PIC18F2410/2510/4410/4510 Rev. B3 Silicon Errata

The PIC18F2410/2510/4410/4510 Rev. B3 parts you have received conform functionally to the Device Data Sheet (DS39636D), except for the anomalies described below. Any Data Sheet Clarification issues related to the PIC18F2410/2510/4410/4510 will be reported in a separate Data Sheet errata. Please check the Microchip web site for any existing issues.

FIGURE 1: SCK PULSE VARIATION USING TIMER2/2

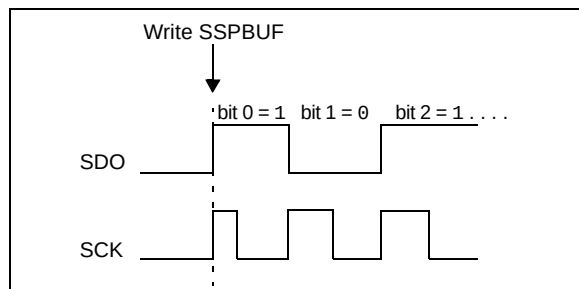
2. Module: MSSP (SPI Mode)

When the SPI is using Timer2/2 as the clock source, a shorter than expected SCK pulse may occur on the first bit of the transmitted/received data ([Figure 1](#)).

To avoid producing the short pulse, turn off Timer2 and clear the TMR2 register, load the SSPBUF with the data to transmit and then turn Timer2 back on. Refer to [Example 1](#) for sample code.
